Product Change Notification

Bourns Announces Change to Housing of the Motorized Slide Potentiometer

Model PSP01 Series

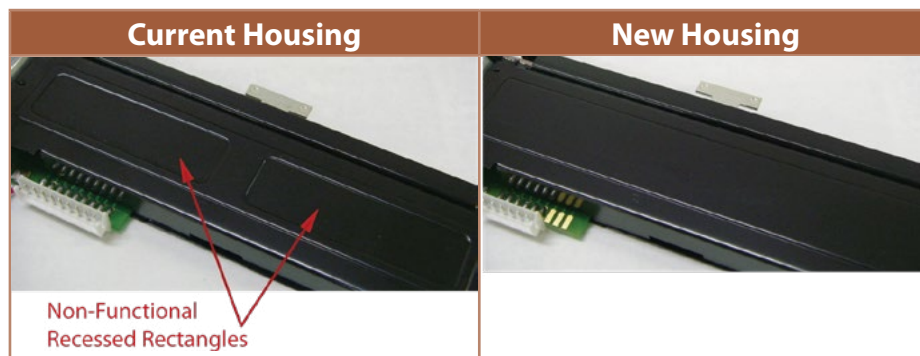
In the spirit of continuous improvement, effective July 15, 2019, Bourns is making a change in the stamping of the housing of the Model PSP01 Motorized Slide Potentiometer. Currently, there are two non-functional recessed rectangles measuring 51.8 mm wide x 13.7 mm high x 0.3 mm deep. This change will remove the non-functional recessed rectangles, resulting in ease of manufacturability of the product.

This change will not affect the function, quality or reliability of the product. The form will change due to the visible difference in the shape of the housing and the fit on the top will change slightly with the removal of the non-functional recessed rectangles. Products can be identified by the date code 1929. Below is a list of affected part numbers.
